ENGINEERING CHANGE NOTICE

Proj. ECN B-714-123

5. Project Title/No./Work Order No. B-714/ER8007
Grouted Waste Disposal Facilities

6. Bldg./Sys./Fac. No.
218-E-16

Ref. Dwg. H-2-77597	Sh. 1	Rev. 2	Prepared By T.K. EHRHARD	Checked By <i>M.A. McLean</i>	ECN No. B-714-123	Page 515
------------------------	----------	-----------	-----------------------------	----------------------------------	----------------------	-------------

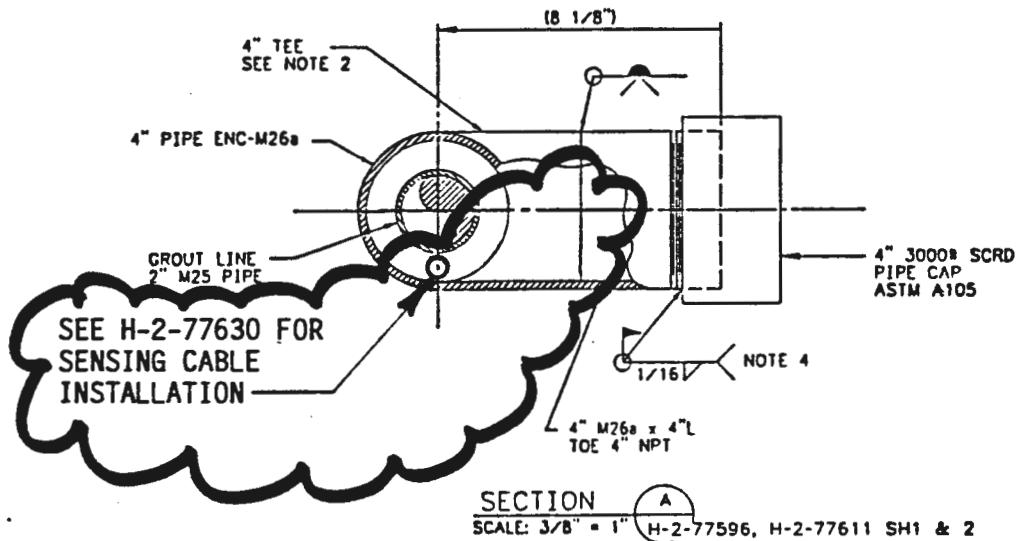
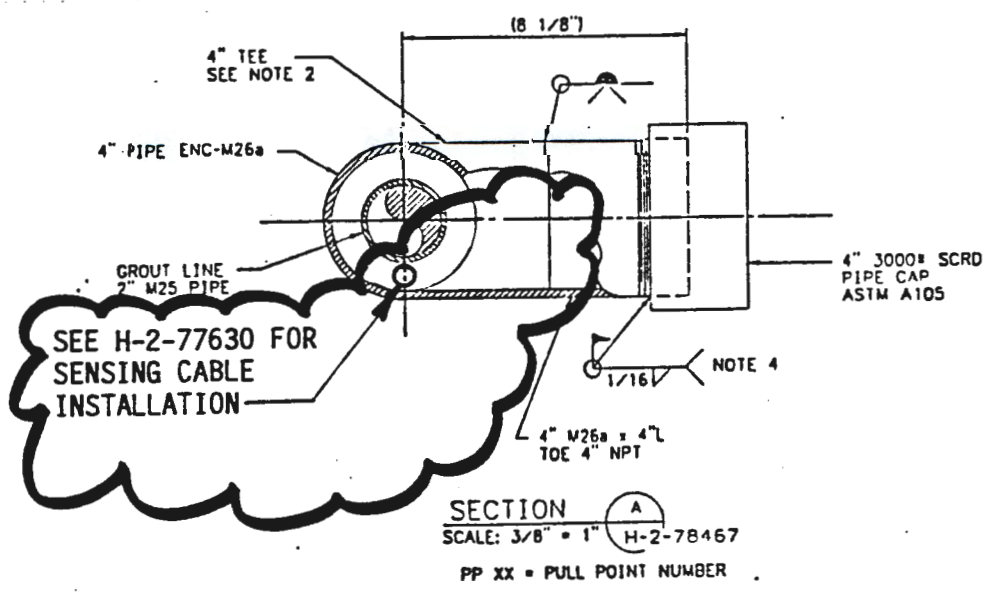
- 1) H-2-77573, SH 2, REV 0
ADD the following dwg to ELECTRICAL column:
H-2-77630 7501 ELECTRICAL SENSING CABLE PLAN & DETAILS
- 2) H-2-77597, SH 1, REV 2
(sc-2) A) Section A (Z E8): Modify - see page 5 of this ECN.
(sc-2) B) Detail 8 (Z F4): Change "TRACETEK END KIT" to read "SENSING CABLE END TERMINATION"

- 6) H-2-78468, SH 1, REV 1
(sc-2) A) Section A (Z E8): Modify - see page 5 of this ECN.
(sc-2) B) Detail 8 (Z F4): Change "TRACETEK END KIT" to read "SENSING CABLE END TERMINATION"
